Airport Campus Redevelopment
***preliminary* Final Environmental Impact Statement (pFEIS)**

September 29, 2022

This document is the *preliminary* Final Environmental Impact Statement for the Airport Campus Redevelopment. Copies of the accepted FEIS will be available for review at the office of the Lead Agency, on the internet: <https://www.northcastleny.com/home/pages/airport-campus>, and at the North Castle Public Library.

Sight Distance Analysis - Cooney Hill Road / King Street
Figure 2-12c

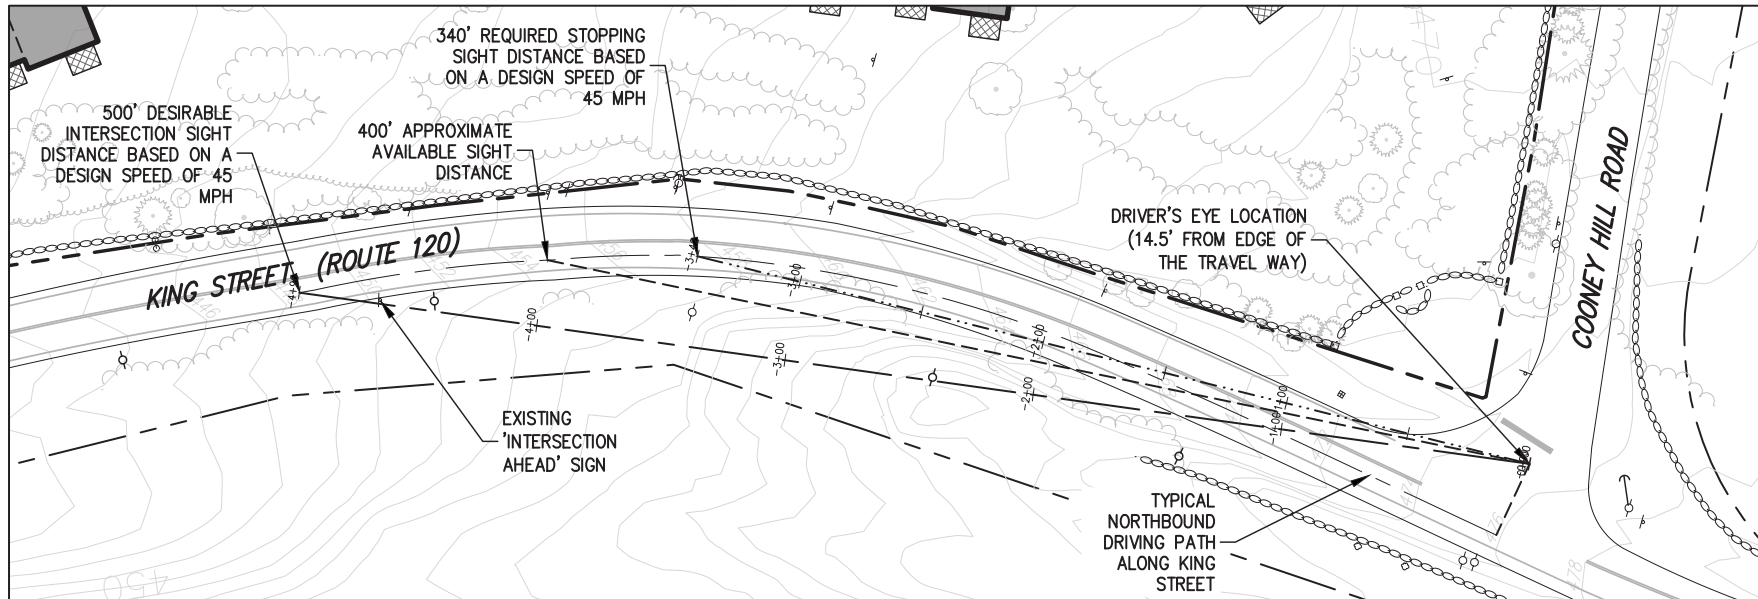
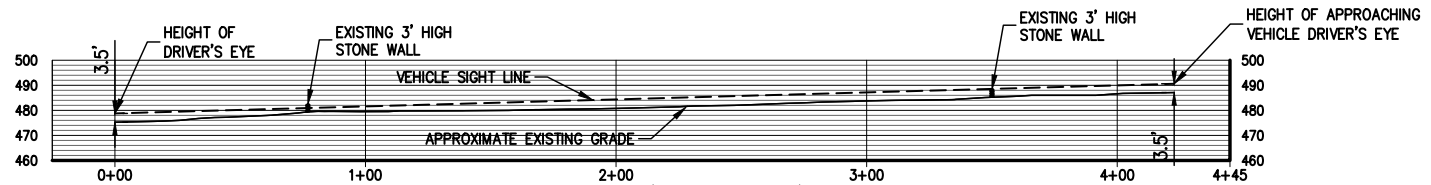
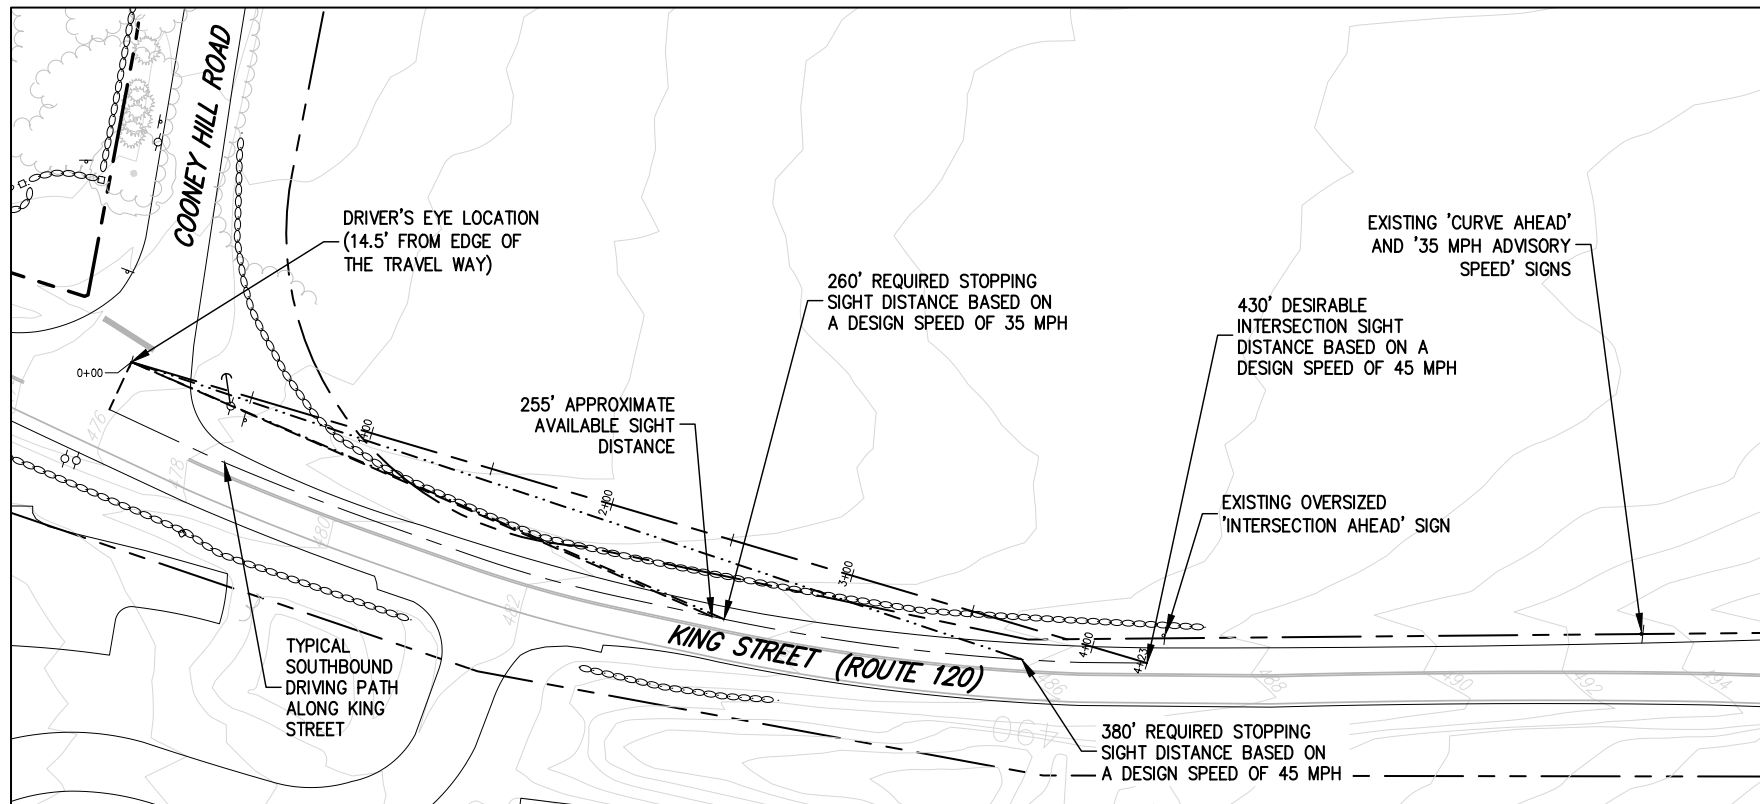
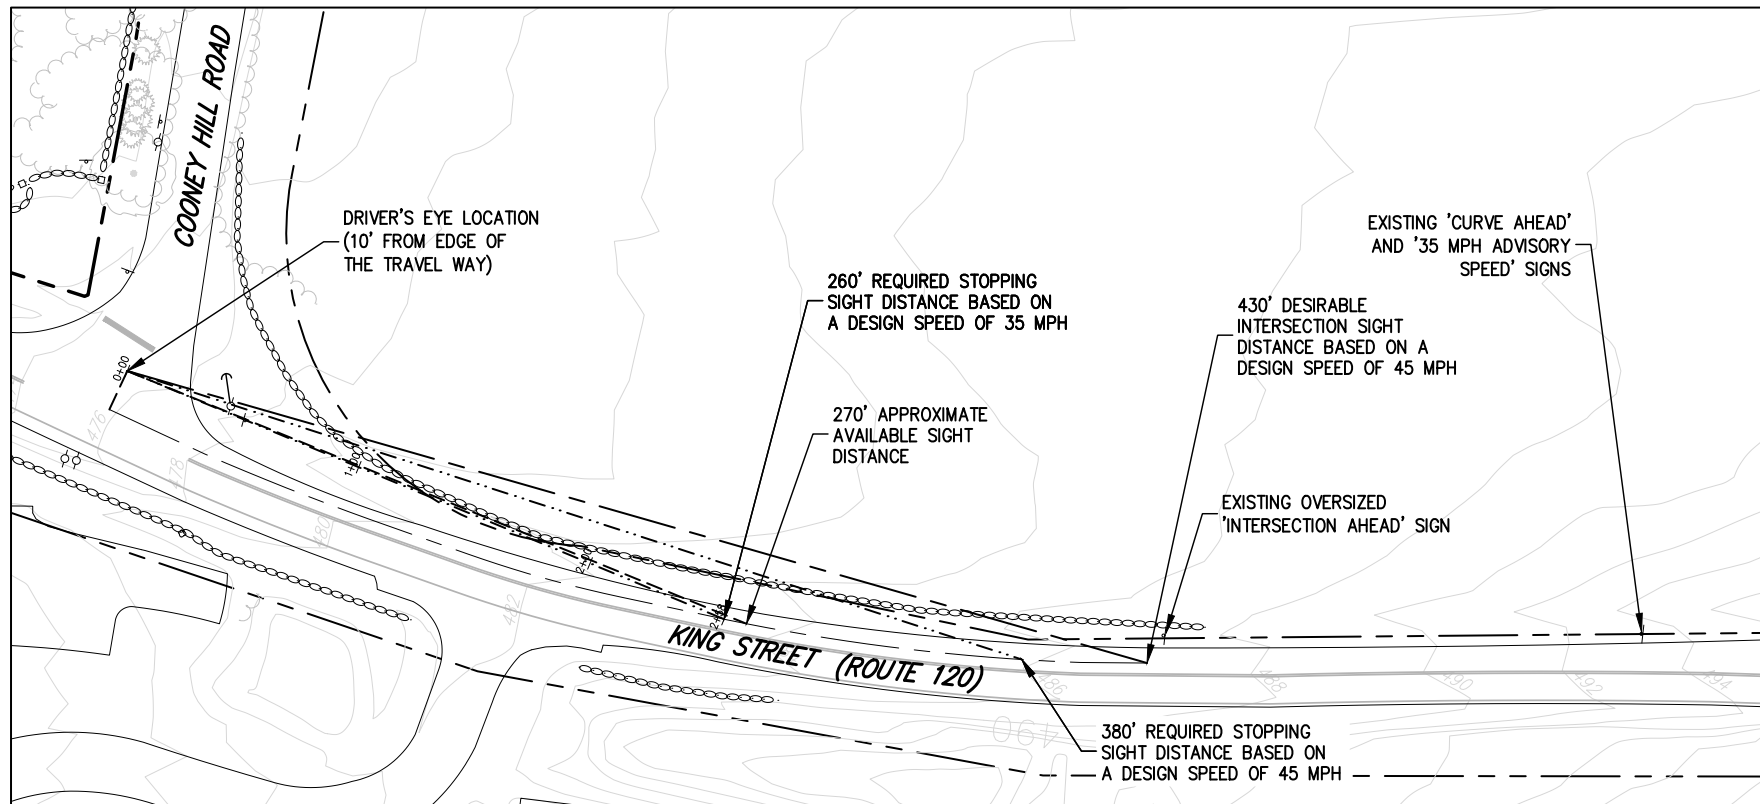
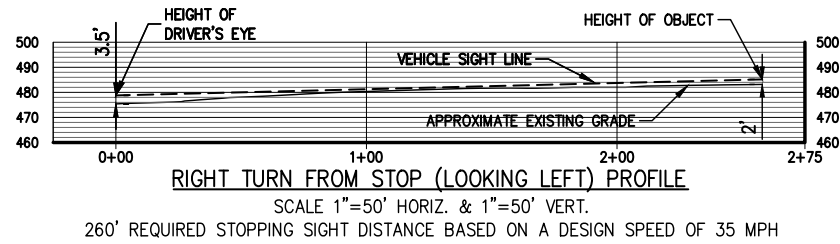
Comment 10-11: Page 10-18 – Chapter 10.D.7 and Figure 10-2 and Appendix G-1, Section L (Stopping Sight Distance (SSD) Analysis): The requirements for SSD should be adjusted for approach grades, as Cooney Hill Road has a downhill grade from east to west. Also, the profiles should have an object height of 2.0 feet at the site driveway, not 3.5 feet as shown. Also, based on a field visit, there is a concern with limited sight distance exiting Cooney Hill Road onto NYS Route 120 (King Street) in both directions. The Applicant should provide an ISD analysis for this intersection and offer any mitigation to improve ISD based on required standards. (Galante_H&H_021)
